KU-RING-GAI COUNCIL

SUBMISSION IN RESPONSE TO ENVIRONMENTAL IMPACT STATEMENT FOR THE NORTH CONNEX TUNNEL PROJECT

9th September 2014

Figure 2.1 : Comparison of assumed SRTM data resolutions

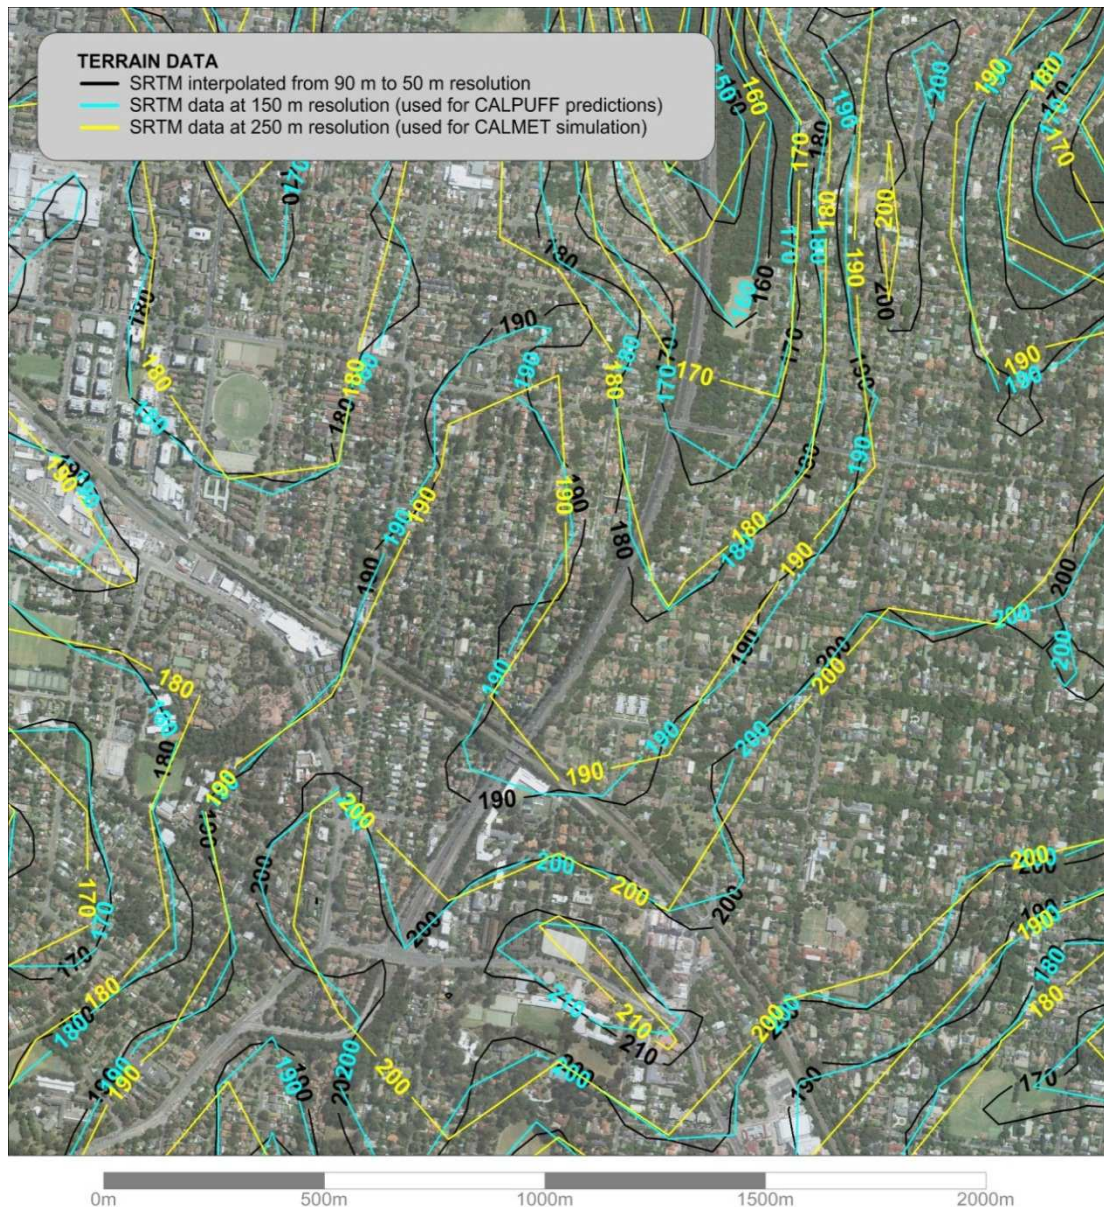
- **Terrain source and resolution:** Figure 2.1 shows the area around the proposed northern ventilation outlet, overlayed with the SRTM terrain data, and including three (3) assumptions on terrain resolution; 50 m, 150 m and 250 m. CALMET Pty Ltd has used the SRTM data, gridded at 250 m resolution. From this figure, it can be seen there are differences between the modelled terrain (250 m resolution) and the “actual” terrain (assuming the 50 m resolution is closest to the actual terrain). Differences are in the order of 5 to 10 m depending on the location. The SRTM data has a limitation as the radar imaging technique does not always map the true surface, especially when the ground is covered by dense vegetation.

The differences between modelled and actual terrain need to be explained, in terms of whether the simulated meteorological conditions in the vicinity of the northern ventilation outlet will change because of the data source (SRTM) and selected resolution.

Figure 2.2 : Receiver locations, Figure 8 extract from Technical Working Paper: Air Quality

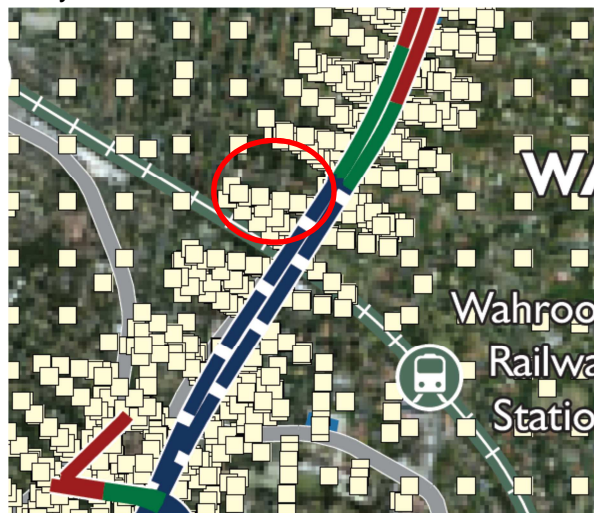
- **Receptor resolution:** In the vicinity of the ventilation outlets, predictions were made at discrete receptors with a grid resolution of 150 m, up to 2.5 km from each outlet. Additional receptors were added along the project corridor, spaced 10, 35, 60, 105, 160 and 225 m from the road centreline (refer to page 45 of the Technical Working Paper: Air Quality). **Figure 2.2** shows the location of the CALPUFF model receptors in the vicinity of the proposed northern ventilation outlet.

From this figure it can be seen there are areas of very little receptor coverage in the model (see for example area circled). This means maximum ground level concentrations, due to emissions from the 15 m high ventilation outlet, may not be identified by the model.

The proponent should demonstrate maximum ground level concentrations have not been under-estimated because of the selected receptor resolution around the ventilation outlets.
